Reply to the comments of referee#1

The manuscript: Updating Thermal Head of Recoverable Autonomous Sonde (RECAS) for Better Drilling Performance in Qilin Subglacial Lake Exploration submitted by Li et al., reports on updates to an existing drilling instrument. The manuscript is well-written and generally easy to follow, also for a non-expert like me in this niche area. The English language is generally good, with only a few odd phrasings (that are still easy to understand).

Figure S1 The structure of the filter

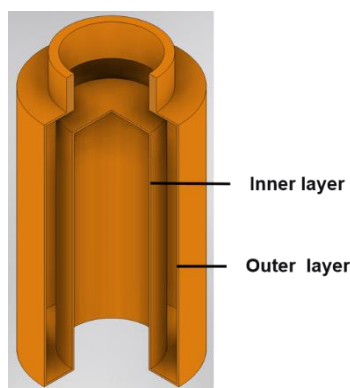
Line 110: The manuscript would benefit from an improved description of the filters used to remove dust, i.e., what materials are used. Further is also not clear to me if the dust can risk clogging the filters or does the design make dust move into the internal cavity? The text states that dust is collected in this internal cavity. How big is this cavity and is there a risk of overfilling it during deep drilling? Please clarify this in the manuscript.

Nevertheless, a real risk of filter clogging exists. To reduce the likelihood of blockage, the contact area between the filter and water was enlarged through a double-layer design. As illustrated in Fig. S1, the two-layer stainless-steel wire screen provides approximately twice the contact area of a single layer. A total of five filters are employed.

“Nevertheless, a real risk of filter clogging does exist. To mitigate this, the contact area between the filter and the water was increased through a double-layer design. The two-layer screen provides approximately twice the contact area of a single layer.”
